IMPERIAL ROAD DESIGN MANUAL
REVISIONS July, 2014

EXAMPLES

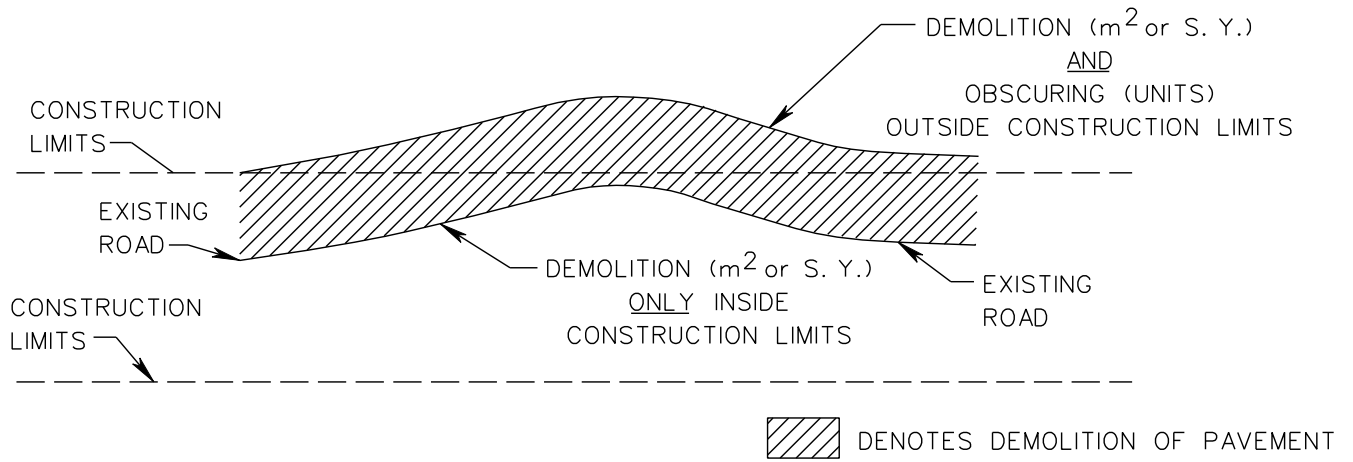
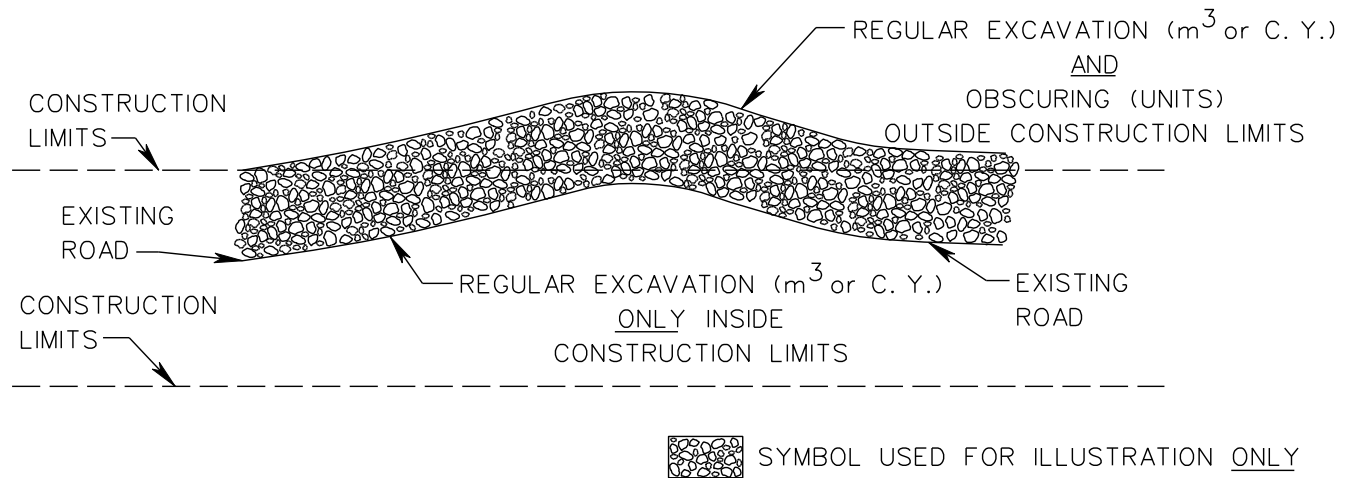
- Page 2E-32 thru 35 – Revised the following language under “DEMOLITION OF EXISTING PAVEMENT AND OBSCURING ROADWAY” from; *“Demolition of pavement and obscuring old road are to be computed and depicted on plans as outlined in IIM LD-47. These items are to be shown on the plans after right of way has been plotted.”* To;

The following criteria are to be used in establishing the pay items for Demolition of Pavement and Obscuring Roadway.

“Demolition of Pavement” is defined as removal of existing pavement structures.

The following definitions should be used when establishing pay items for Demolition of Pavement (a special Provision Copied Note is available from the Construction division).

- *Demolition of hydraulic cement concrete pavement will be measured and paid for as Demolition of Pavement (Rigid) S.Y. (m2).*
- *Demolition of asphalt concrete pavement will be measured and paid for as Demolition of Pavement (Flexible) S.Y. (m2).*
- *Demolition of a combination of hydraulic cement concrete pavement and asphalt concrete pavement will be measured and paid for as Demolition of Pavement S.Y. (m2).*
- *Obscuring Roadway will be measured and paid for as Obscuring Roadway in Unit **

FIGURE C-8-5 TYPICAL ENTRANCE RAMP

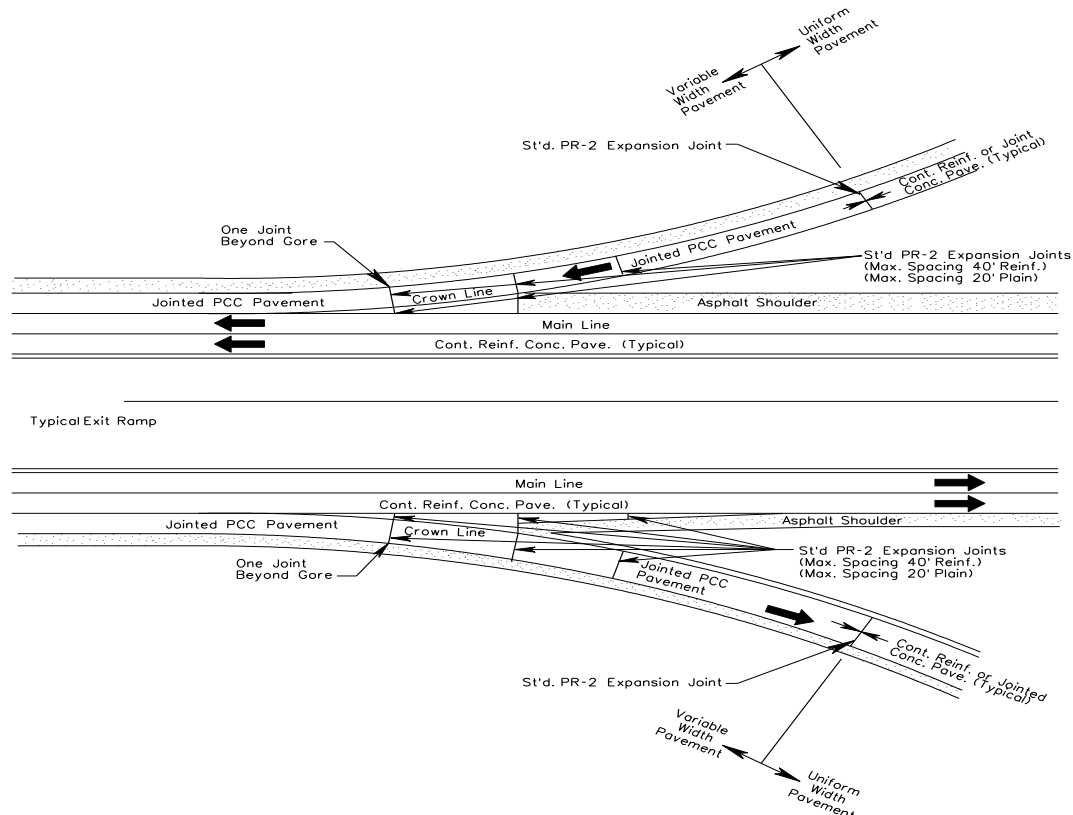
- Page C-82 – Revised “FIGURE C-8.1 RAMP GORE FOR EXIT RAMP” to add 14’ dimension to exit ramp pavement width.
- Page C-85 – Revised “FIGURE C-8.4 RAMP GORE FOR ENTRANCE RAMP” to add note about ramp left paved shoulder width.
- Page C-87 – Added the following language;

Each entrance and exit ramp must be examined on an individual basis to determine joint arrangements. The joint arrangement details are to be made a part of the plans.

The following sample drawings depict typical joint arrangements at entrance and exit ramps, and are not intended to be all encompassing.
